Date: 13th April 2021

Your ref: 15/00314/AOP

Re: South West Milton Keynes, Updated Transport Assessment

Location: Land South Of The A421 West Of Far Bletchley North Of The East West Rail Link And East Of Whaddon Road Newton Longville

Junction 18: Windmill Roundabout – Mitigation Proposal

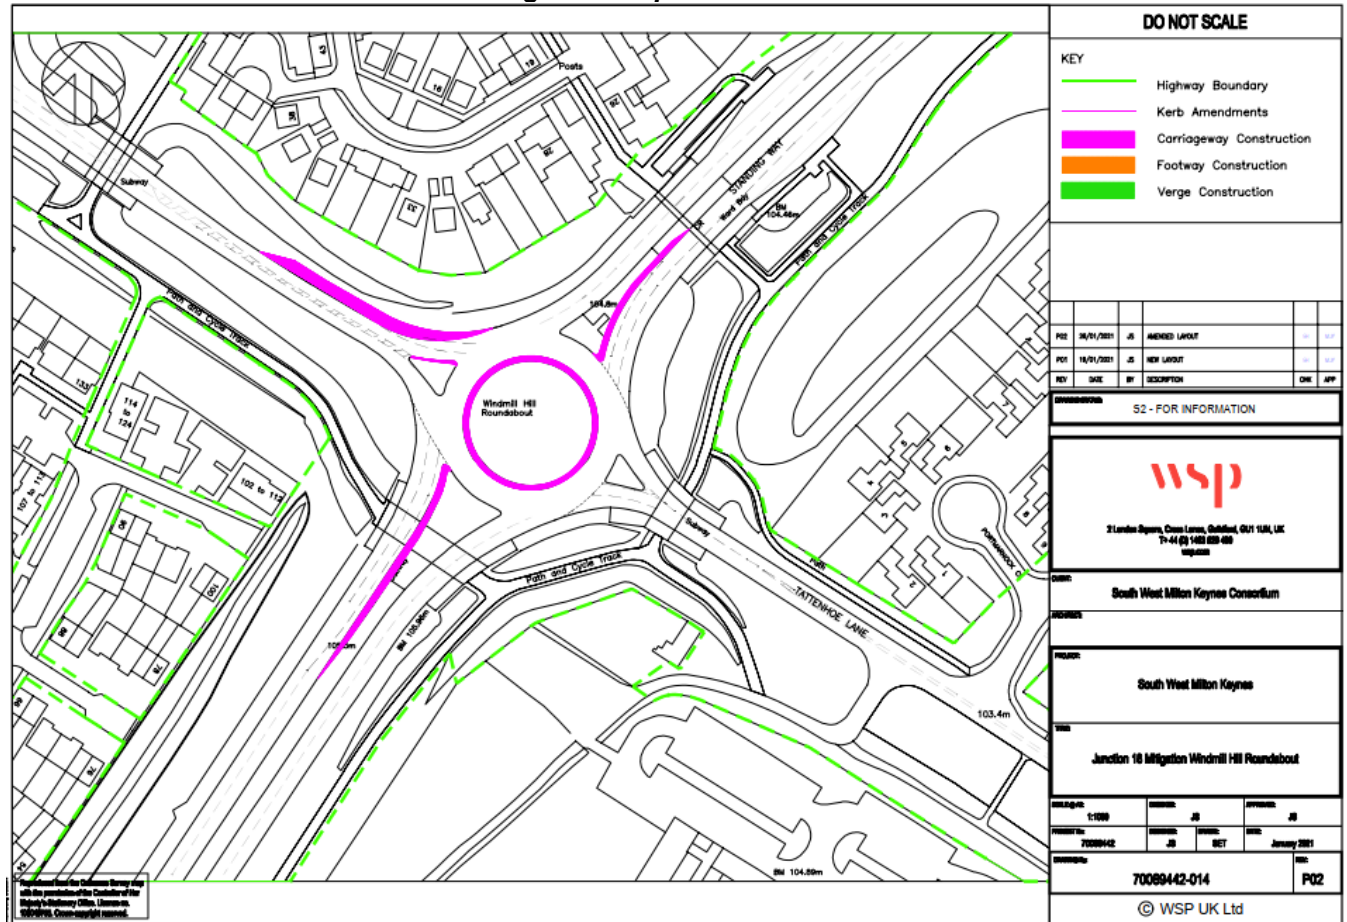
The predicted decrease in capacity due to development traffic would be considered significant and the Applicant has submitted a mitigation scheme. This includes kerb widening on all Tattenhoe Street and A421 Standing Way (N) and (S) with amended road markings on Tattenhoe Lane to create a longer flare and wider entry, all with the intent on improving capacity.

The results show that with the provision of the proposed mitigation that overall the junction results would see an improvement considering both peaks compared to 2033 DN existing layout with the demand weighted Junction Delay reducing in the AM from 225.69 to 163.86 seconds and in the PM from 136.59 to 133.11 seconds.
